TAB Punchlist - CFA 02258 Independence Center

Prepared by Will Turnbough

Feb 2, 2026

#338 [EXHA 499] [NEW] CRITICAL (MISC) – RR Exhaust Grille

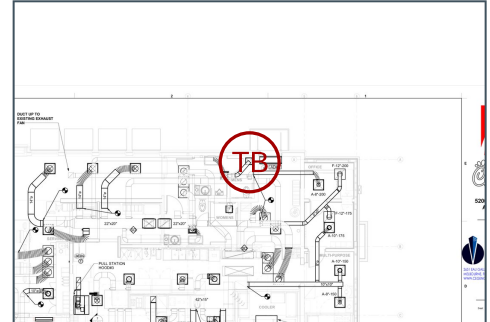
INCORRECT SIZED DUCT ATTACHED TO EXHAUST GRILLE IN MEN'S RESTROOM. MEASURED OPENING OF DUCT THAT IS INSTALLED FOR AIRFLOW READING. NEEDS TO BE REPLACED WITH PROPER FITTING.
